AGENDA

ST. TAMMANY PARISH PLANNING COMMISSION MEETING 6:00 PM - TUESDAY SEPTEMBER 8, 2020 ST. TAMMANY PARISH GOVERNMENT COMPLEX PARISH COUNCIL CHAMBERS 21490 KOOP DRIVE, MANDEVILLE, LOUISIANA

2020-2010-PP

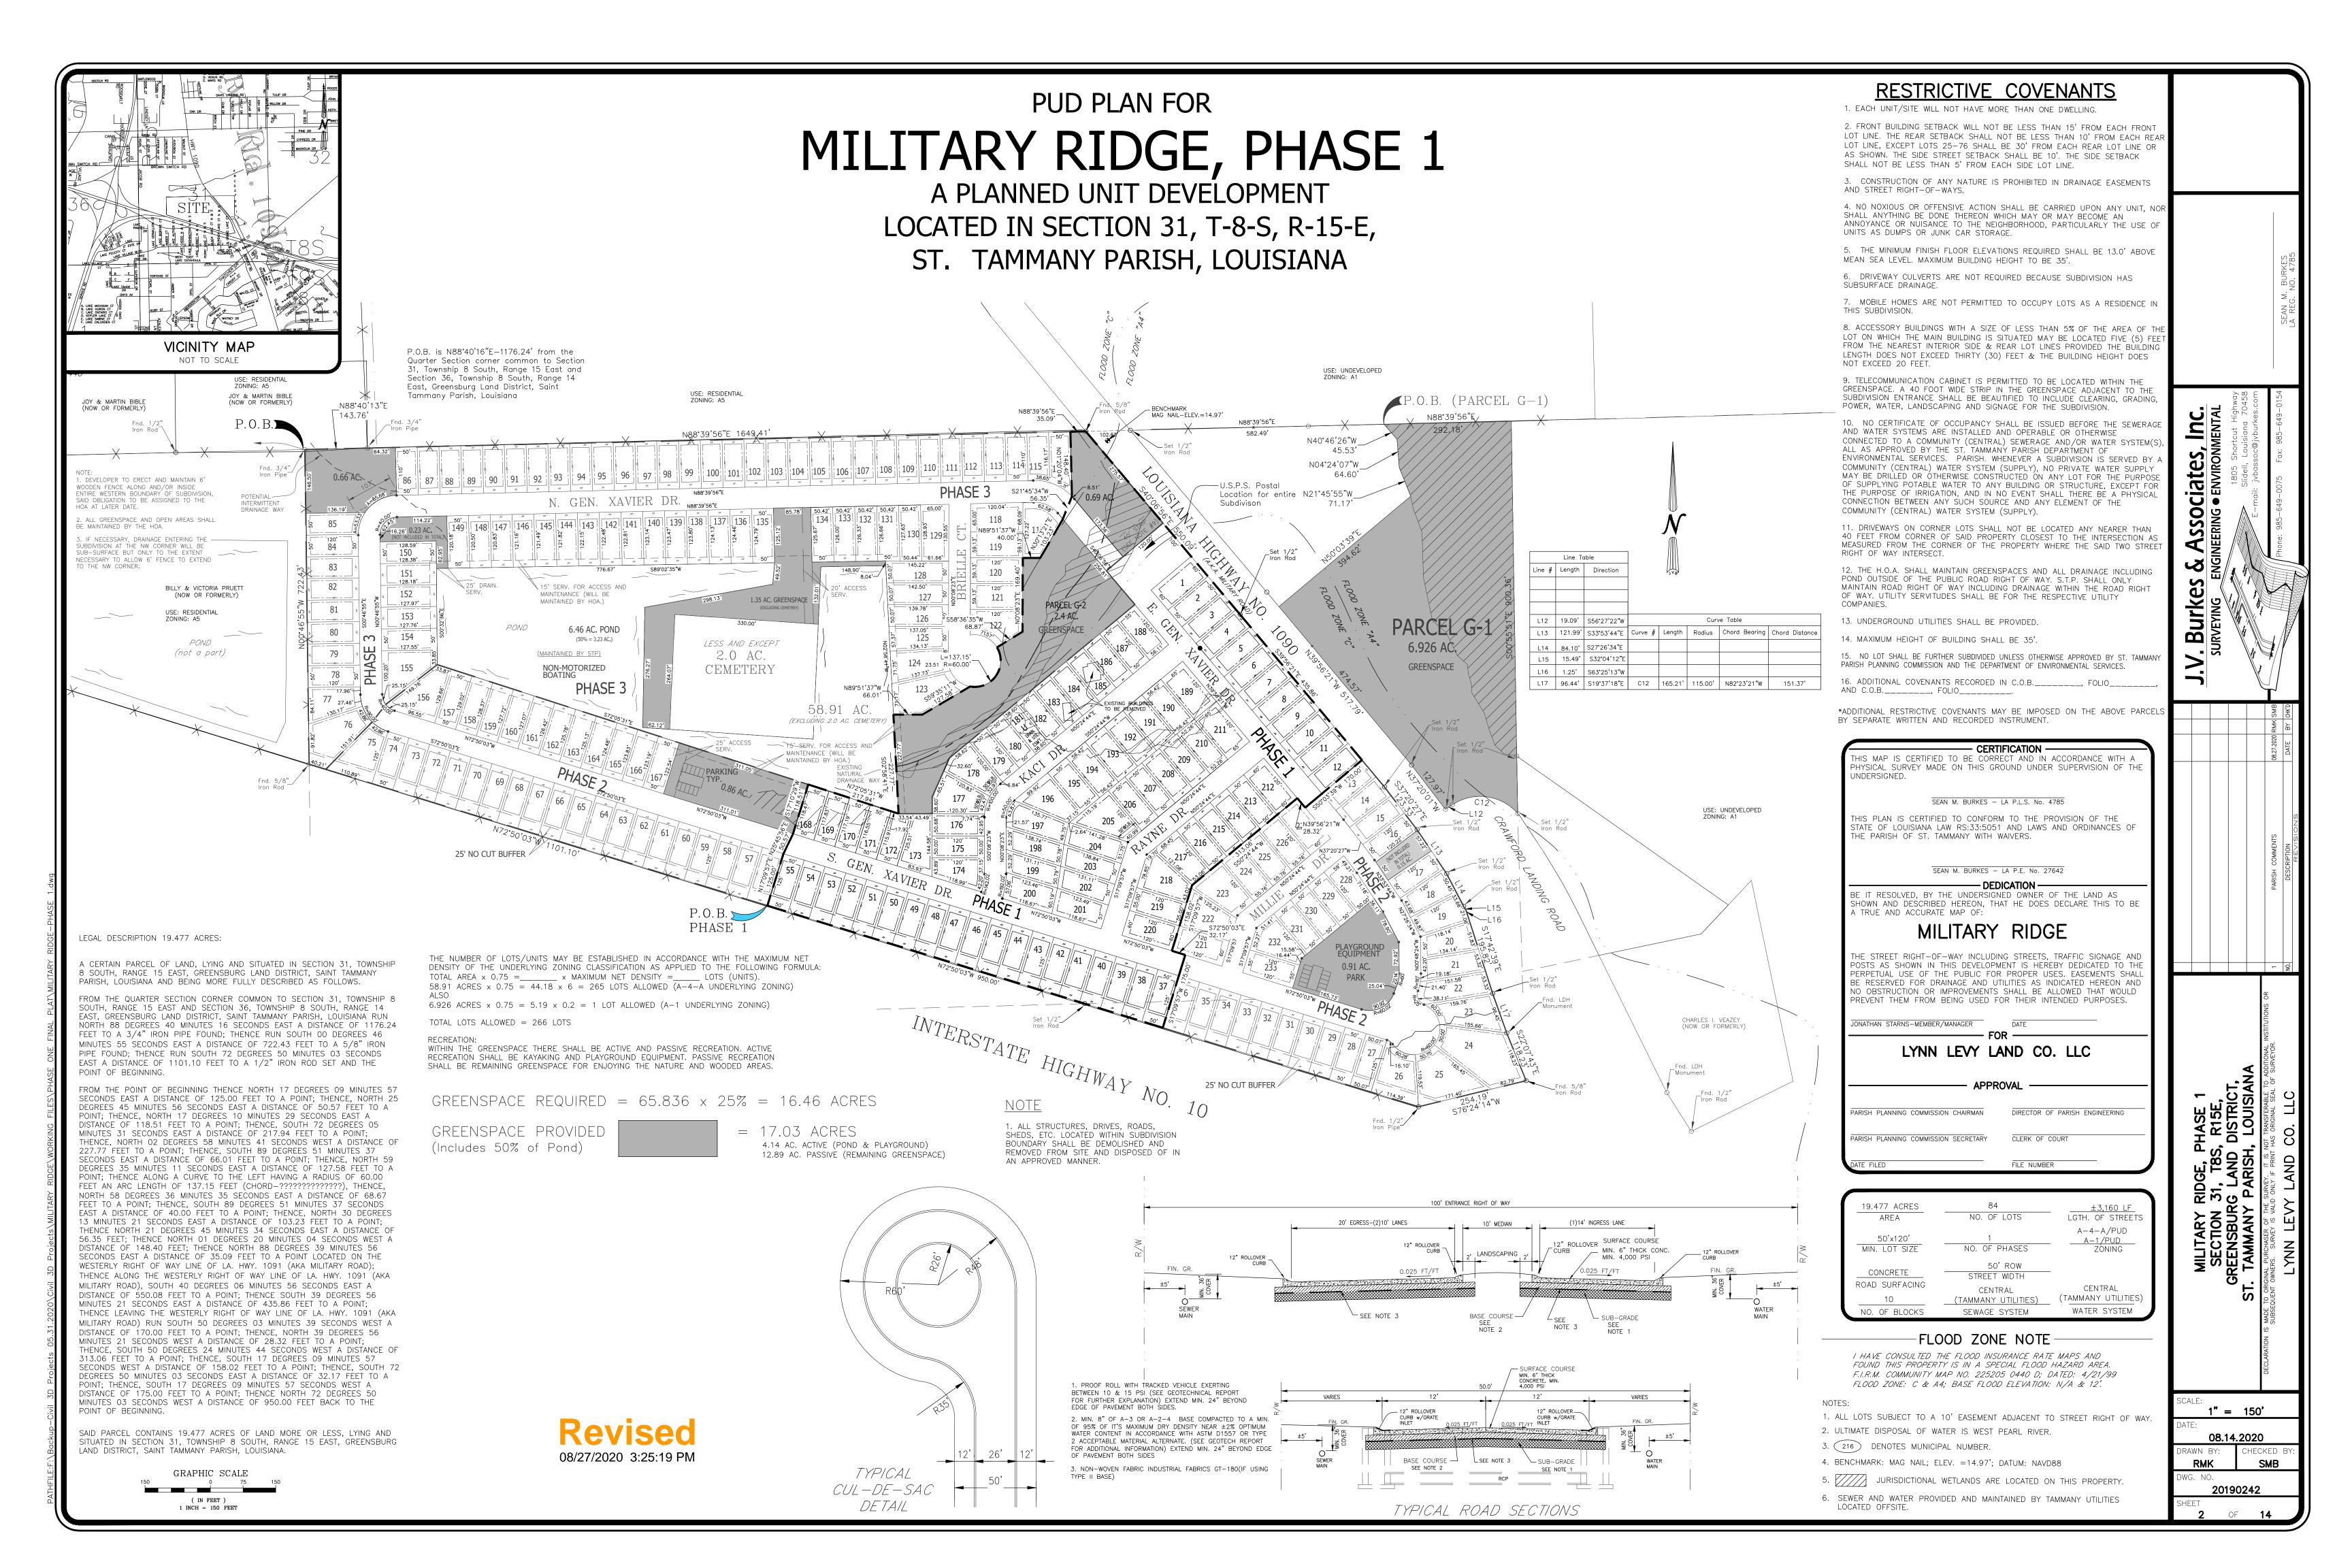
- 1. Provide a recreational development plan. Include a time schedule for the development and the entity whom shall be responsible for the liability and maintenance of the recreational amenities.
- 2. All infrastructure needs to either be public or private. Revise the plats dedication language and restrictive covenants as needed.
- 3. Detention area and outfall required for Phase 1 must be included within the boundaries of this phase.
- 4. The T.I.A. provided with this submittal is incomplete and does not contain all the previously required intersection outlined in the T.I.A. scope of this development. The T.I.A. will need to be updated to reflect the required intersections and information.
- 5. Provide a current completed/executed "Fill & Grading Statement" for this development.
- 6. Construction drawings need to be stamped by a LA licensed Civil Engineer (Typical)

- 7. Individual parcel numbers/labels need to be provided for all greenspace parcels in this development.
- 8. Minimum lot size allowable for this development is 50' x 120' per the approved PUD. Revise Lots #177, 178, 196, 205 & 218 accordingly.
- 9. Revise to state "Preliminary Plat" instead of "PUD Plan".

- 10. Provide proposed elevations at all property corners on the Drainage Plan.
- 11. Provide profile drawings showing all centerline street grades and subsurface drainage for this phase of Military Ridge.
- 12. Provide sizing verification that the existing drainage culverts under Hwy 1090 (Military Ridge) are adequately sized to handle the proposed drainage flow.
- 13. Relabel Lot #181 to Lot #181U in accordance with the revised Preliminary Plat. (Typical all sheets)
- 14. Need a dedicated drainage and access servitude for the subsurface drainage infrastructure located on Lot #168. Update and revise all applicable plan sheets accordingly.
- 15. Provide a dedicated drainage and access servitude for the excavation area and natural drainage

- 16. Provide pipe sizing calculations for the proposed 18" PVC pipe running between Lots #149 & 150 in the hydrologic study for the 100 year storm event.
- 17. Provide a grading (cut/fill) plan showing all fill and cut areas within all phases that include proposed elevations and contours and include in the Drainage Impact Study.
- 18. Show the 15' servitude for access and maintenance along the rear property line on cross-section B-B.

- 19. Provide a water and sewer letter of capacity for this phase of Military Ridge from Tammany Utilities.
- 20. Provide written plan approval from Tammany utilities for this phase of Military Ridge.
- 21. Relocate the water line from Lot #182 to run along the utility lot #181U.

22. Revise Typo to state "End of Roadway" Assembly. (Typical all call-outs)

Driveway Waiver Exhibit

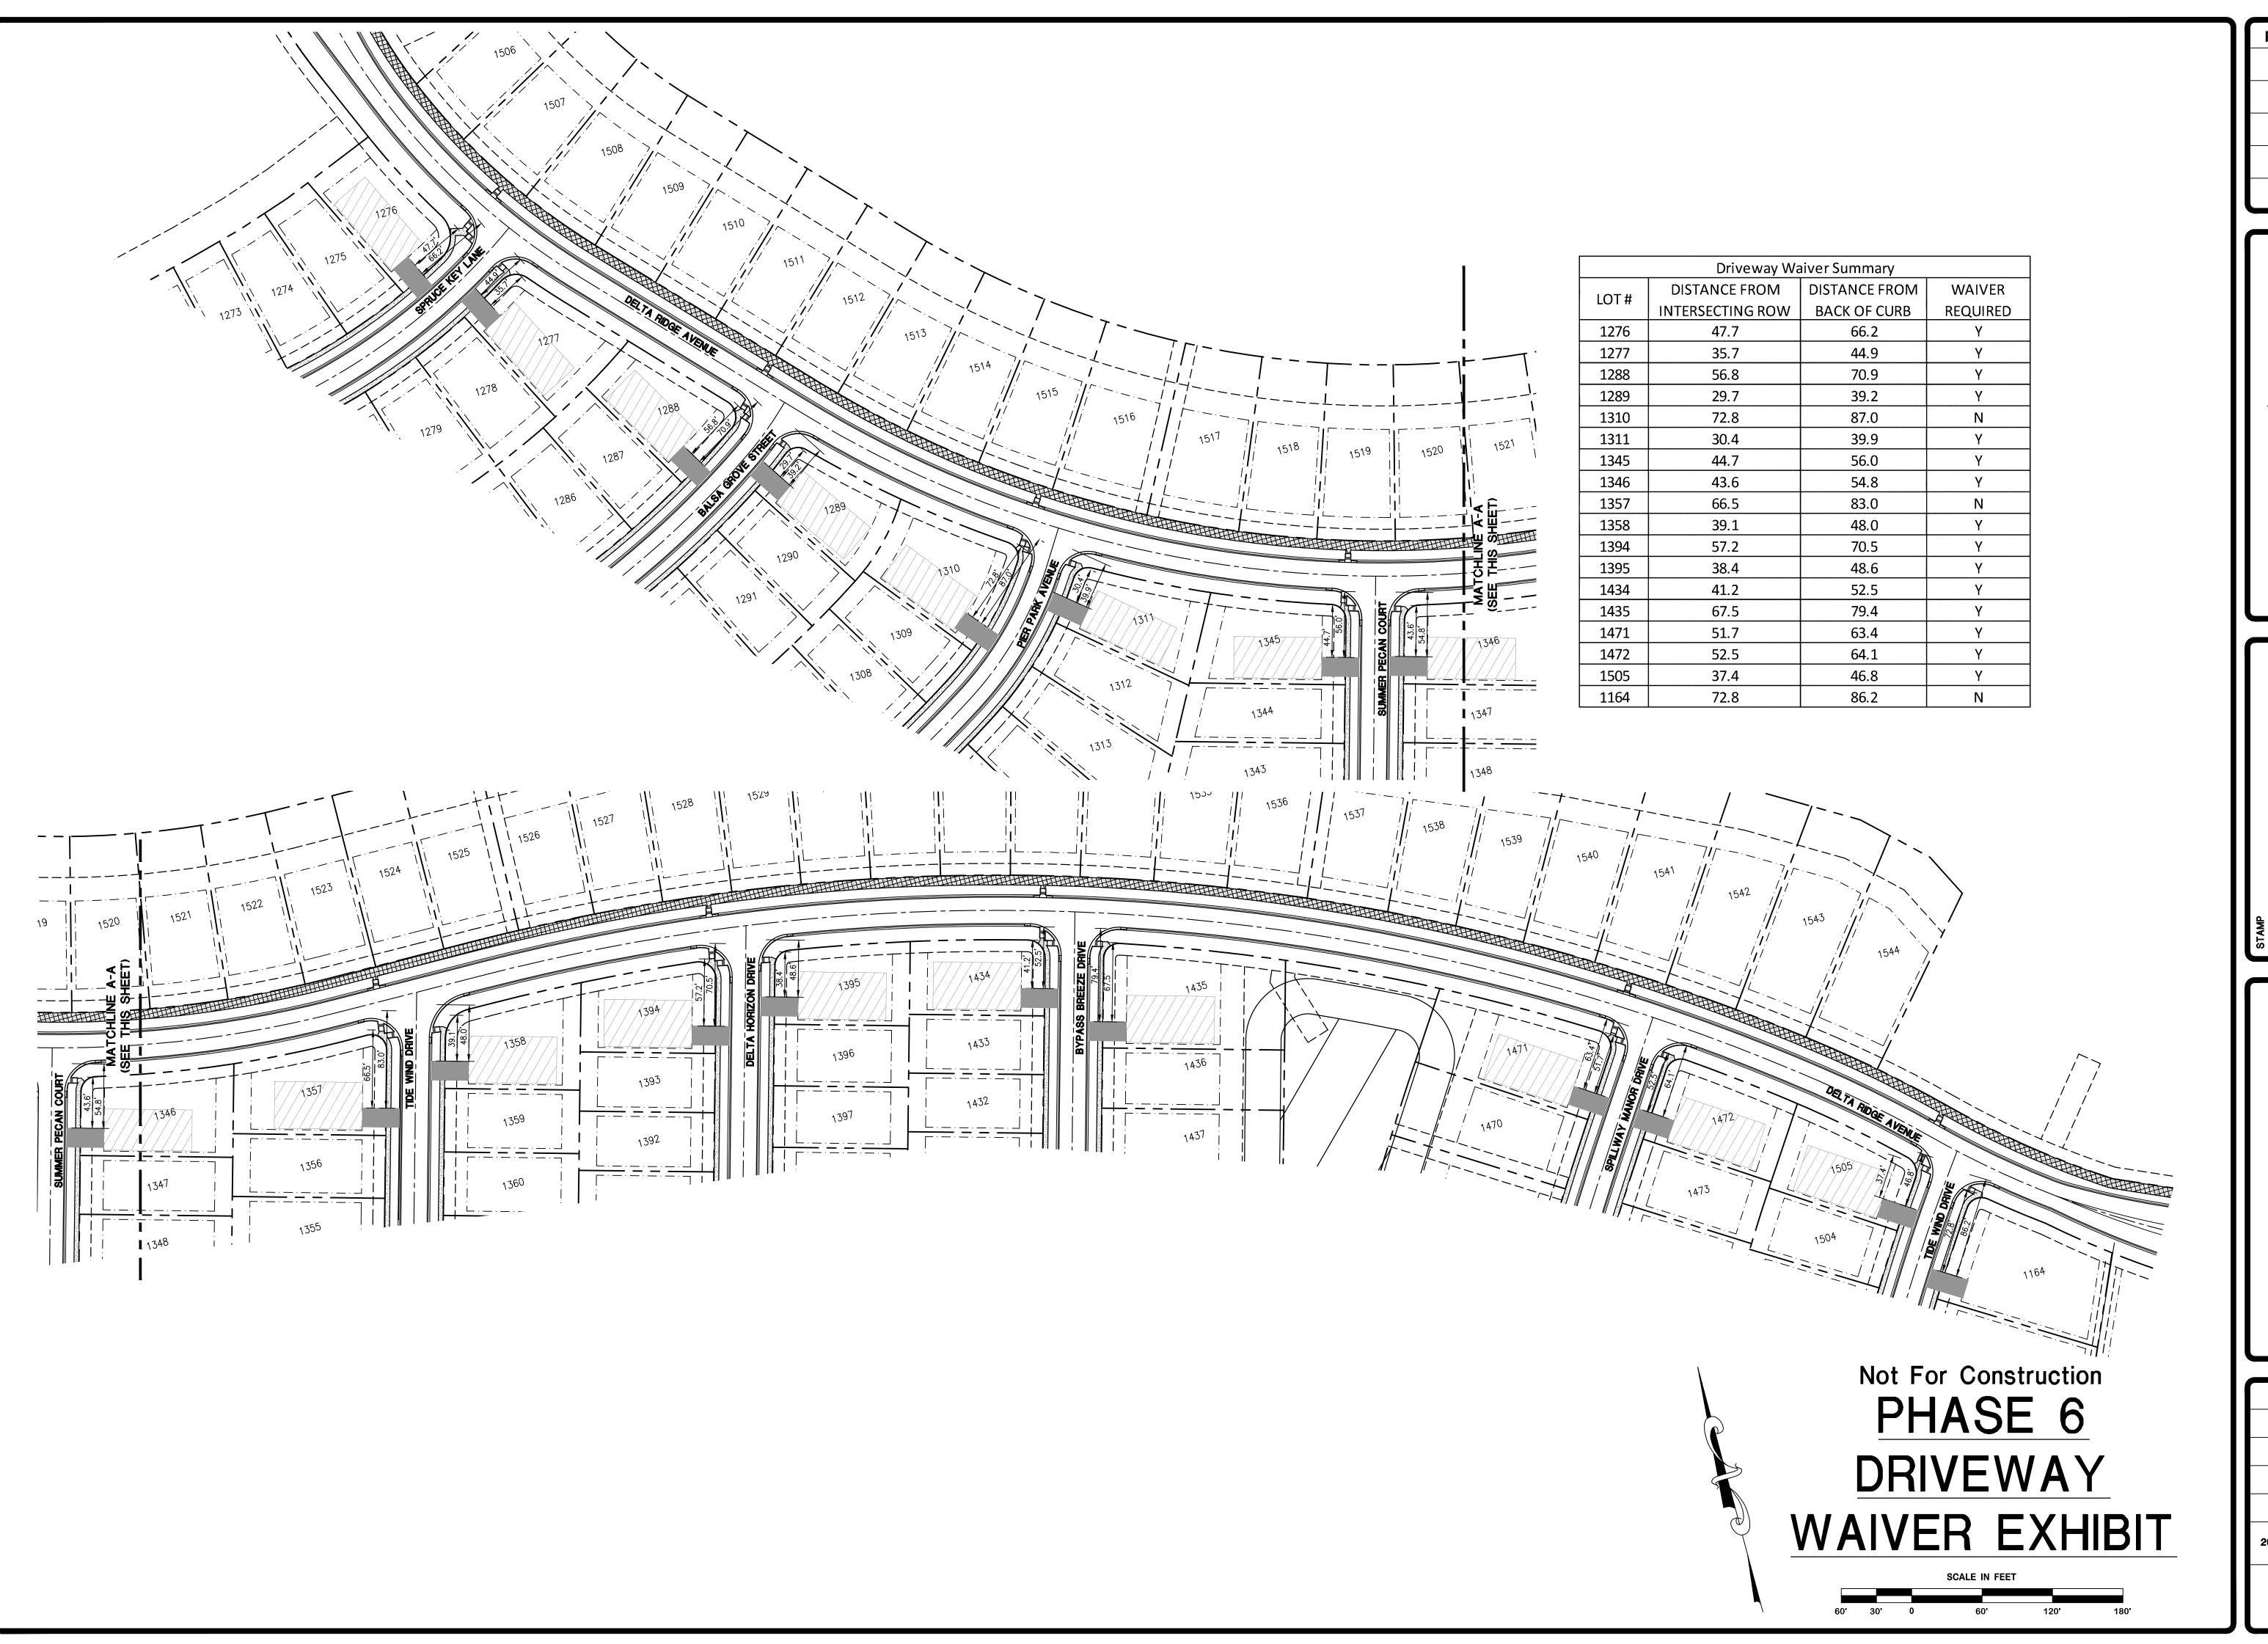
1. A waiver of the minimum driveway requirement is being requested for lots referenced below and as outlined on the attached Driveway Waiver Summary Exhibit (Sheet Ex – 1.1). In order to approve this waiver request a 2/3rds majority vote of the full membership of the commission (8 members) is needed, pursuant to Section 125-224 Waiver of Regulations, of Chapter 125 – Subdivision Regulations. (The following lots are requesting this waiver: Lots #1276, 1277, 1288, 1289, 1311, 1345, 1346, 1358, 1394, 1395, 1434, 1435, 1471, 1472 & 1505)
